10/687,582

C14-163313M/YAH (NGB.039Cont)

AMENDMENTS TO THE DRAWINGS

FIG. 1

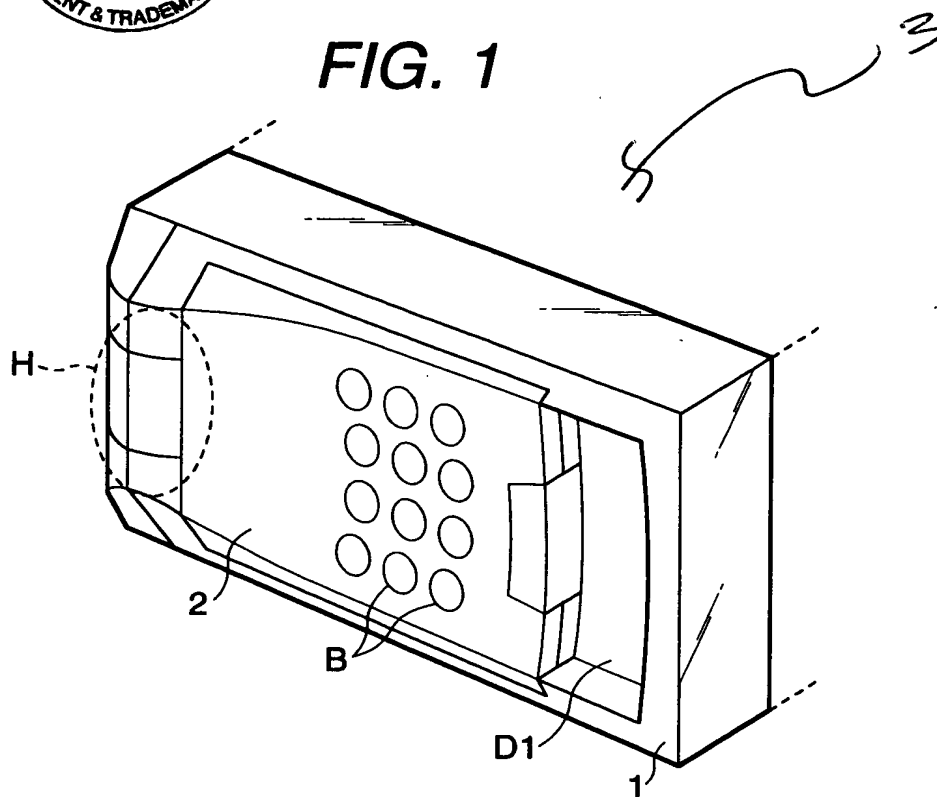
The attached drawing sheet includes a change to Figure 1 to add a label "3" for the dashboard of the automobile upon which the present invention is mounted. This sheet replaces the original sheet which contains Figure 1.

The Examiner objected to the drawings for failing to show the feature that the present invention is intended to be mounted on a surface of an automobile. Applicants believe that the above drawing and specification changes address this concern and respectfully request that the Examiner reconsider and withdraw this objection.
